ENGINE REBUILD REPORT

Motor Vessel Columbia

SUBJECT: M/V COLUMBIA; Engine  
Rebuild Report **MARCH 31, 1981**  
(JACOBSON REPORT)

Date: October 27, 1981  
 To: Dave Thomsen  
 From: G. E. Trussell  
 Subject: Alaska Marine Highway  
 M/V COLUMBIA  
 Jacobson Rebuild Report

Figure 15

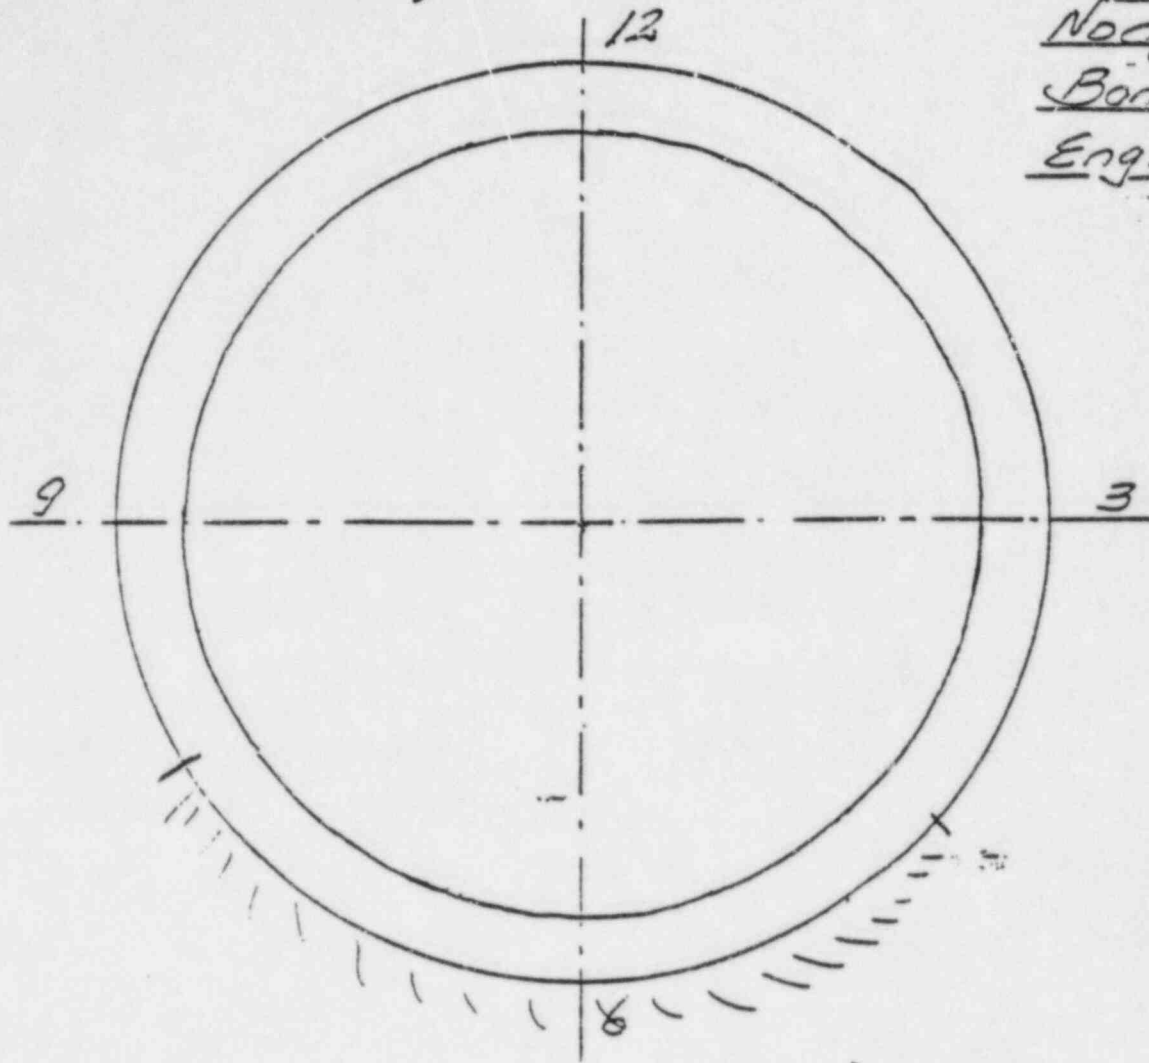
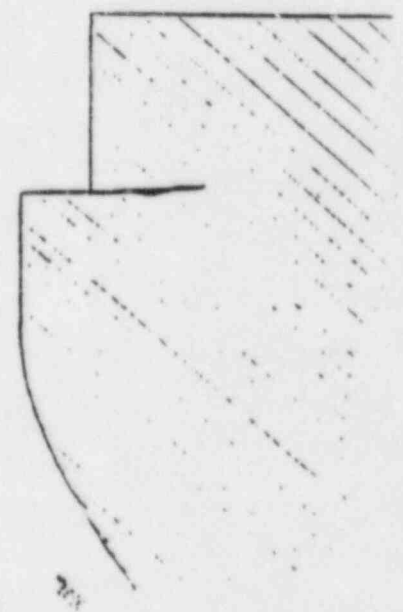
Laminar fractures outward from the root of the counterbore in cylinders 3 and 4 of the left bank of the starboard engine (Figure 15).

Confirmation of the extent of the above fractures by showing their entrance at the metal surface in the roots of the counterbore in cylinders 3 and 4 of the left bank of the starboard engine.

5. The laminar fracturing of the left block of the starboard engine has rendered it unserviceable; it or the entire engine must be replaced.
6. Because the remaining three blocks have been shown to have radial cracks about several of the cylinders, this condition must be closely monitored to observe the cylinder diameter growth in an attempt to perform corrective maintenance before major problems occur.
7. Plan to replace the remaining three blocks in the near future.
8. Consider redesign of the upper portion of the block for replacement to alleviate observed block failure.
